**CITY OF PORTLAND, MAINE
DEVELOPMENT REVIEW APPLICATION
PLANNING DEPARTMENT PROCESSING FORM
Planning Copy**

The Longfellow at Ocean Gateway

Re: The Longfellow at Ocean Gateway
Major Site Plan Review - Additional Information

Summary of Changes Related to Internal Reconfiguration of the Longfellow Residences for Consideration as Minor Amendments to Site Plan and Subdivision Approvals Issued May 5, 2006

REVISED FLOOR PLAN
@ FIRST FLOOR LOBBY

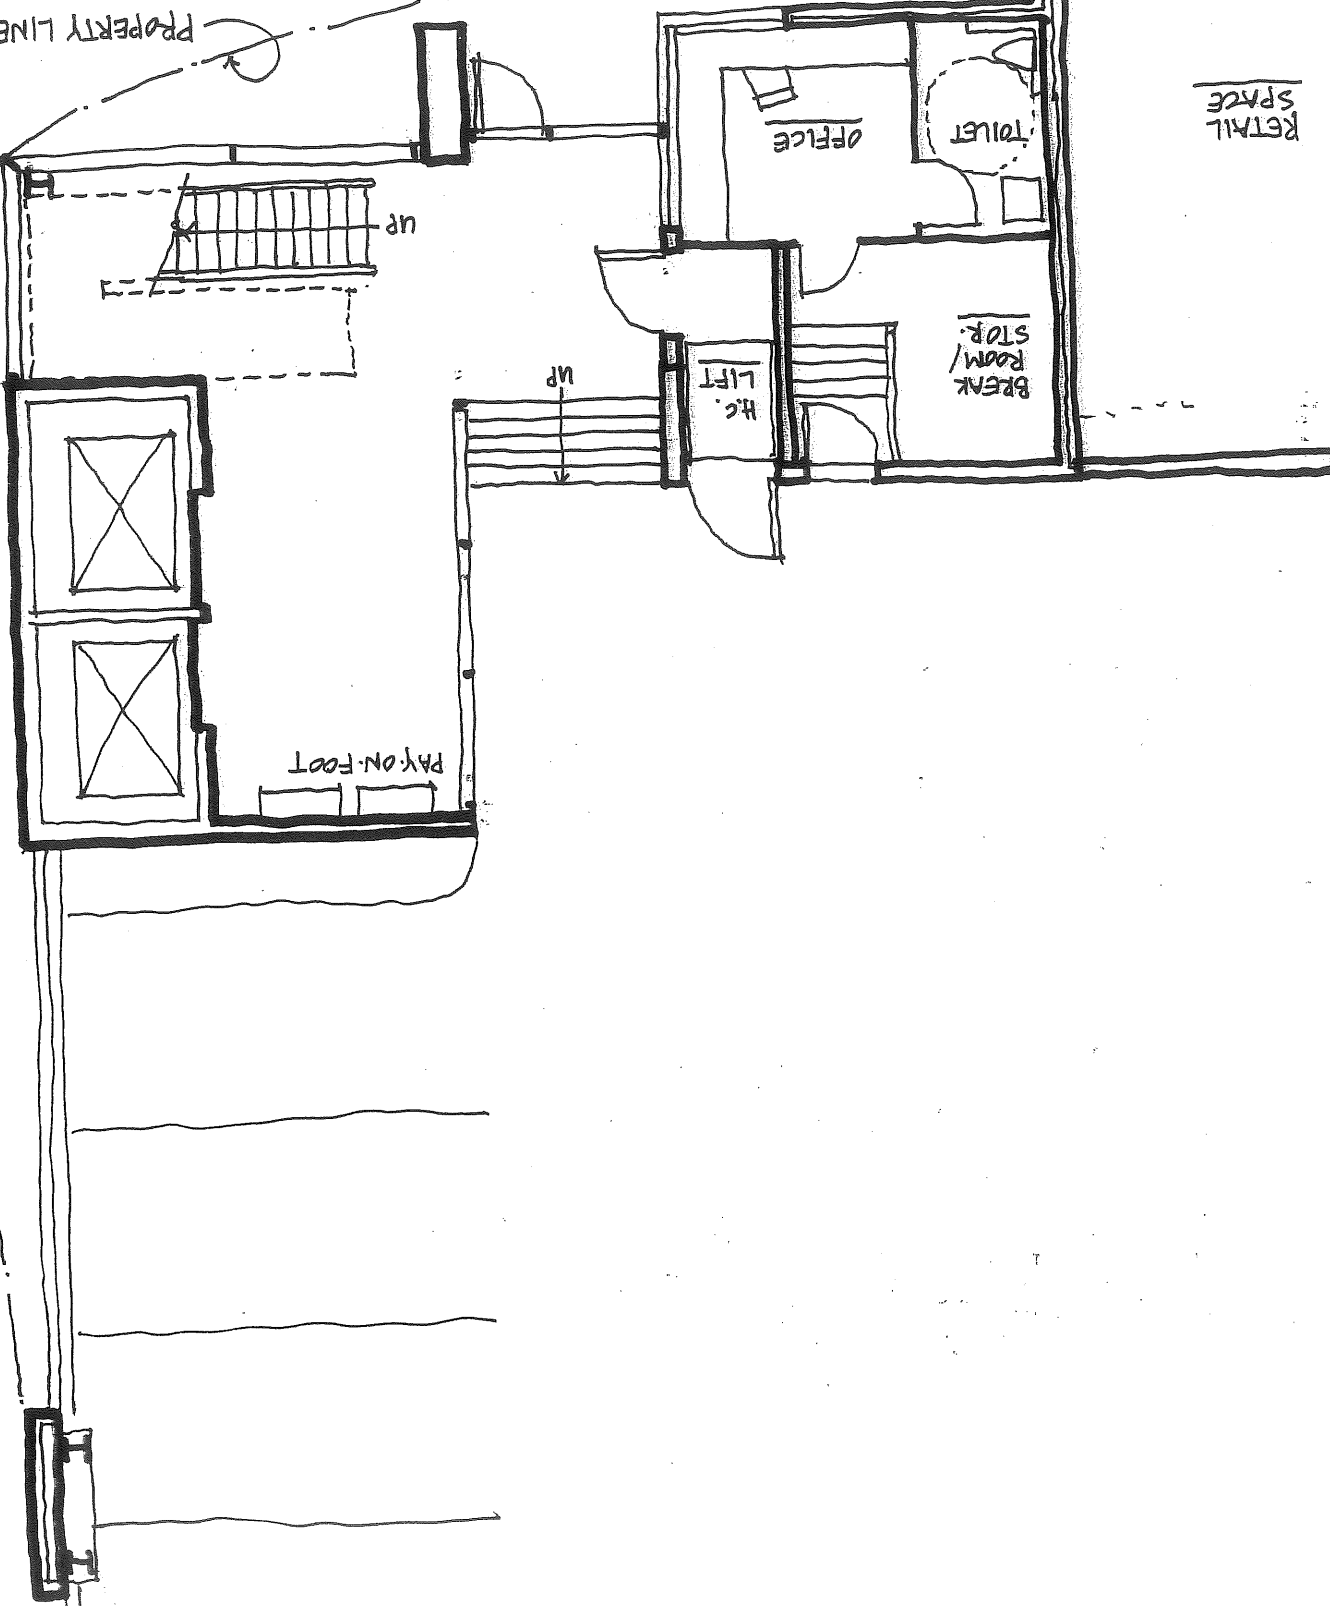
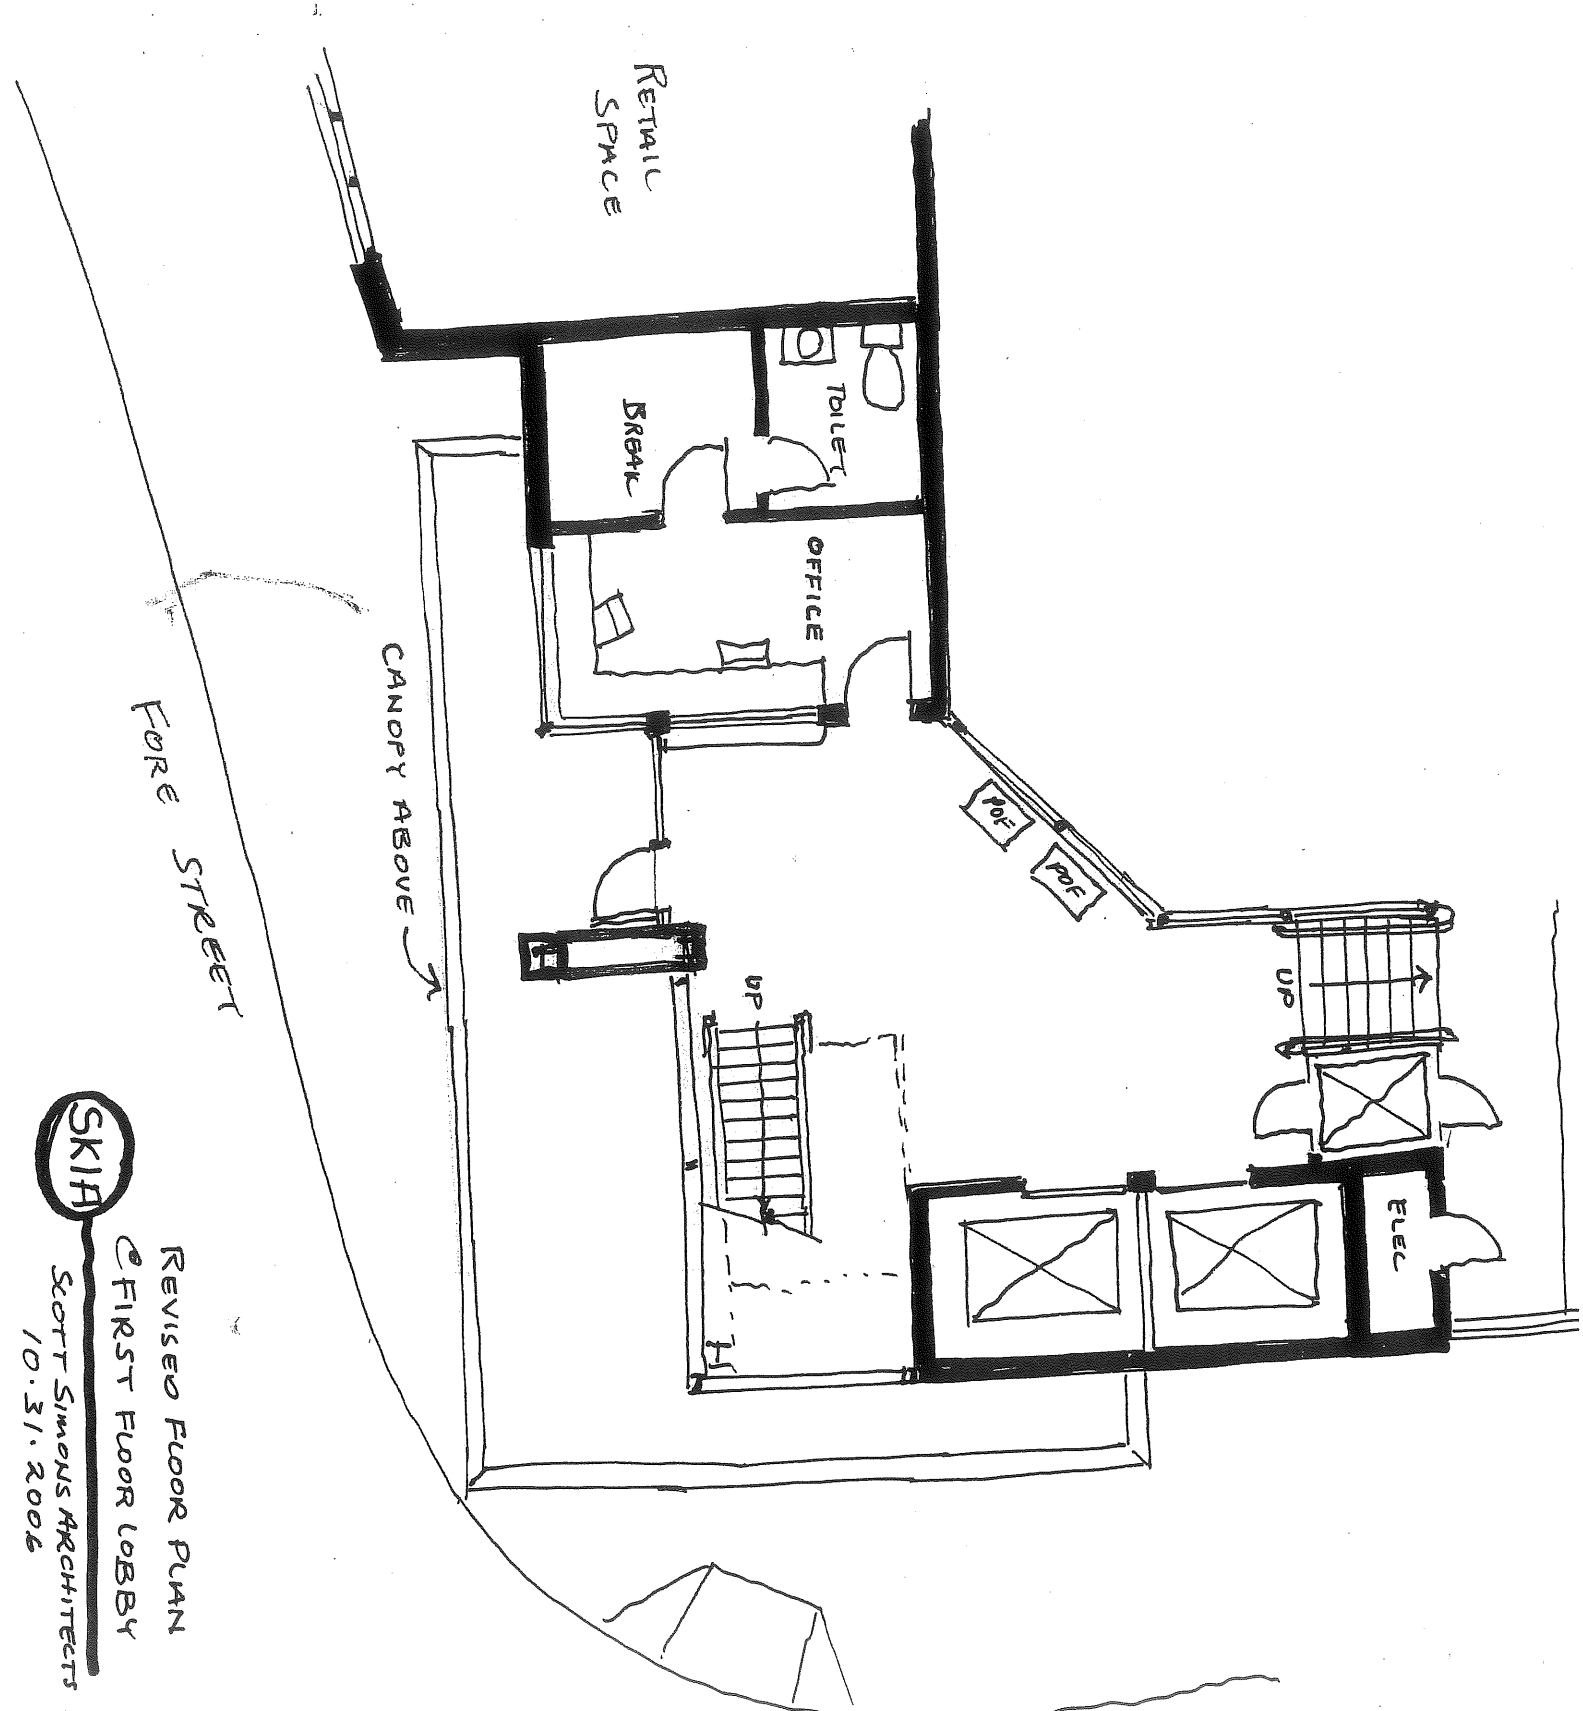
c. Fore Street: In the approved submission, the building had a single-loaded corridor along Fore Street. The units opened up to the waterfront views and four of the floors along Fore Street had corridor and elevator lobby walls fronting the street. The proposed scheme currently changes this entire wing to a double loaded corridor. The result is a more residential feel to the Fore Street Elevation as well as greater efficiency in the building floor plan.

RE: The Longfellow - Impacts on Ocean Gateway Stormwater Conveyance and Treatment Measures

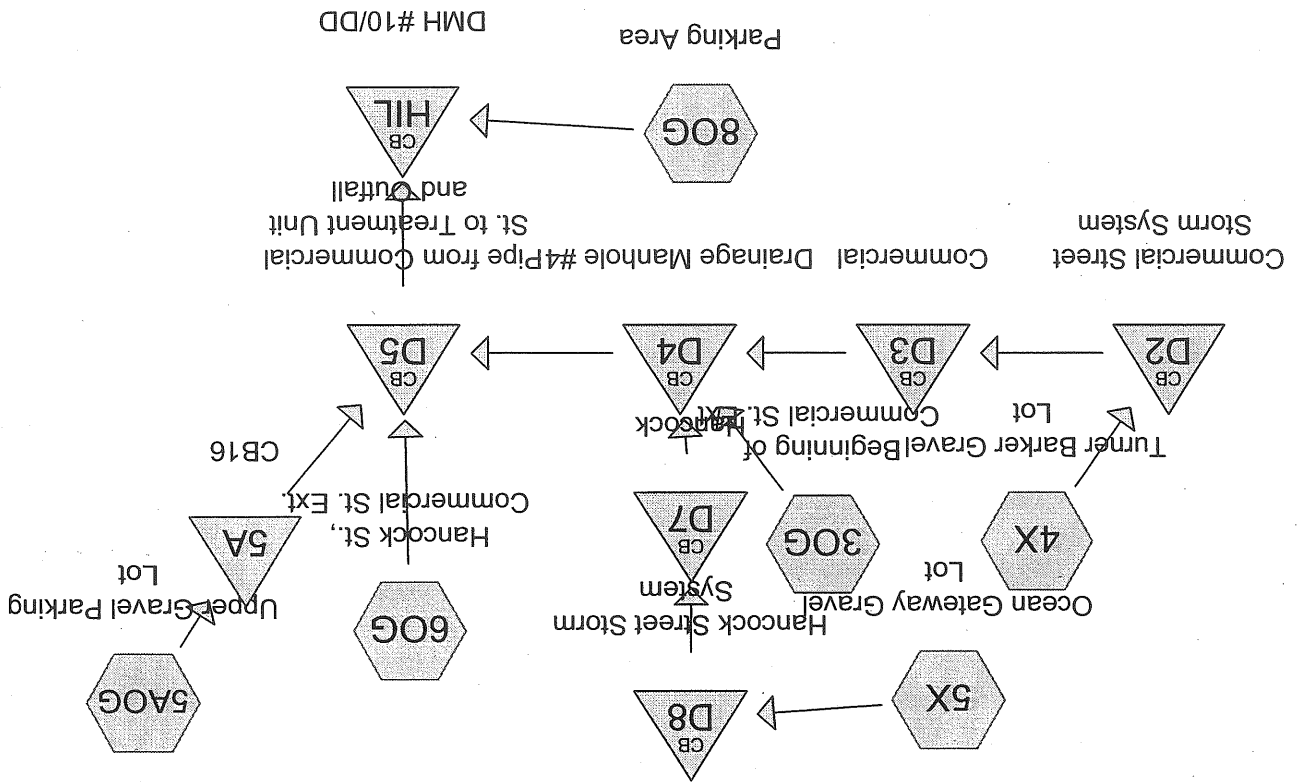
The purpose of this information is to address Planning Board Motion C-Waivers, 1-Stormwater Quantity Standard, Condition (i). Specifically, the Condition states "[t]hat the applicant shall design and fund a stormwater bypass at the Ocean Gateway stormwater quality unit to mitigate increased flow through the City stormwater system resulting from the subject project. The design of the bypass shall be presented to the Public Works Department for review and approval prior to issuance of the building permit."

As an alternative to the bypass structure, the Applicant proposes the use of subsurface stormwater detention structures at the Longfellow Residences and Retail complex and at the Parking Garage to mitigate the increased flow through the City stormwater system. As you know, we have held preliminary discussions with Eric Labelle, City Engineer, regarding this and he generally supports the proposal. The subsurface detention structures have been indicated on Sheet C201A Stormwater Detention Plan, attached to this submission.

As shown in Table 2, the peak runoff rate through the stormwater treatment unit will be reduced as a result of the Longfellow project. The reduction in peak runoff will be accomplished through the use of subsurface stormwater detention at the Longfellow Residences and Retail complex and the Parking Garage.

Subsurface stormwater detention will be used at the Longfellow Residences and Retail complex and at the Parking Garage to control runoff. Through the use of subsurface detention, the area that drains to the City stormwater collection system will be expanded to include the Longfellow Parking Garage and adjacent open area without increasing the peak runoff rate at the Ocean Gateway Stormwater Treatment Unit #2. In fact, the peak runoff rate is slightly decreased. No additional infrastructure is required at the Ocean Gateway site to accommodate runoff from the Longfellow project.
